MIAMI BEACH PLANNING DEPARTMENT

Staff Report & Recommendation

SUBJECT: PB23-0625 1509 – 1515 Washington Avenue.

An application has been filed requesting a conditional use approval for a Neighborhood Impact Structure (NIS) for a new 7-story hotel exceeding 50,000 square feet, and a Neighborhood Impact Establishment (NIE) that includes, an alcoholic beverage establishment or restaurant located on the top floor of a building, whether fully enclosed, partially open, or open to the sky, including all open-air portions above the roof-top, which is located on a property that is within 200 feet of a property containing a residential unit, pursuant to Chapter 1, Article II, Section 1.2.2.4; Chapter 2, Article V, Section 2.5.2; and Chapter 7, Article V, Section 7.5.5.4 of the Miami Beach Resiliency Code.

Delivery and Sanitation

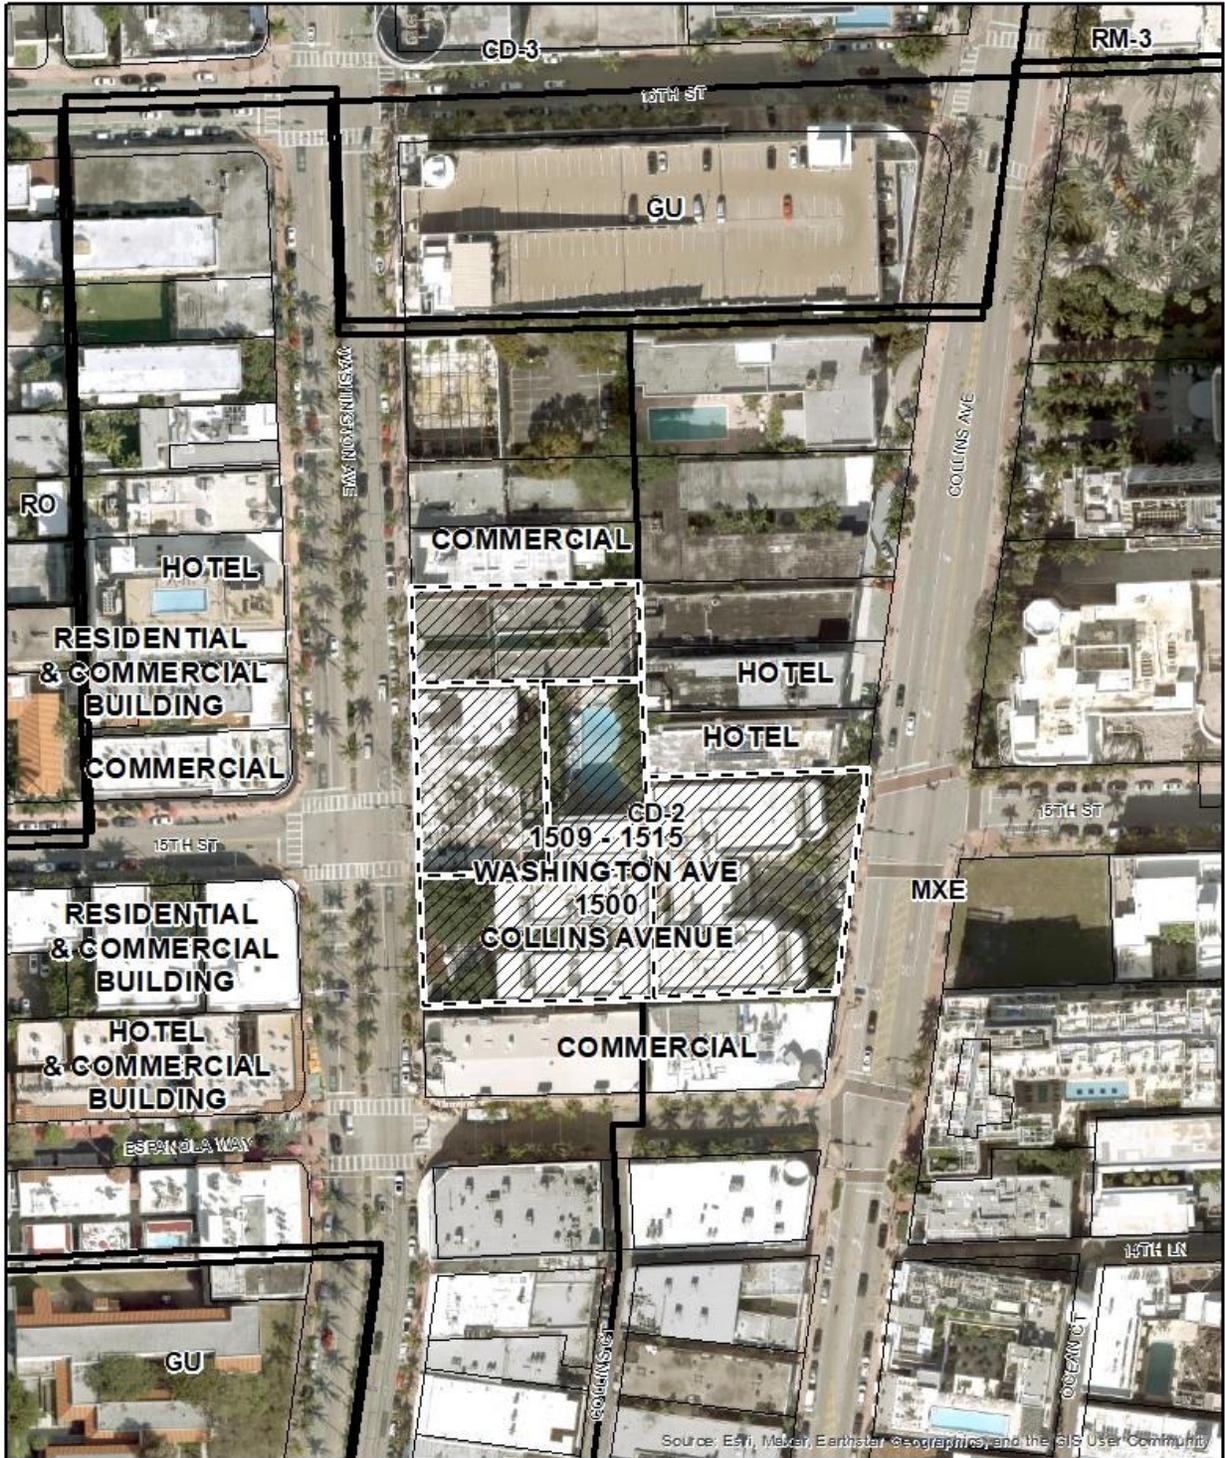
Pursuant to Section 5.2.6 of the LDR's, the project requires four (4) loading spaces onsite. The applicant is requesting a waiver from the Historic Preservation Board for this requirement in order to utilize the existing loading zone located north of the proposed project. Staff has recommended conditions to limit loading to off-peak daytime hours in order to minimize traffic disruptions and minimize noise impacts on surrounding properties.

Trash rooms are proposed at the south side of the property. Additionally, staff has recommended hours for trash pickups consistent with loading hours.
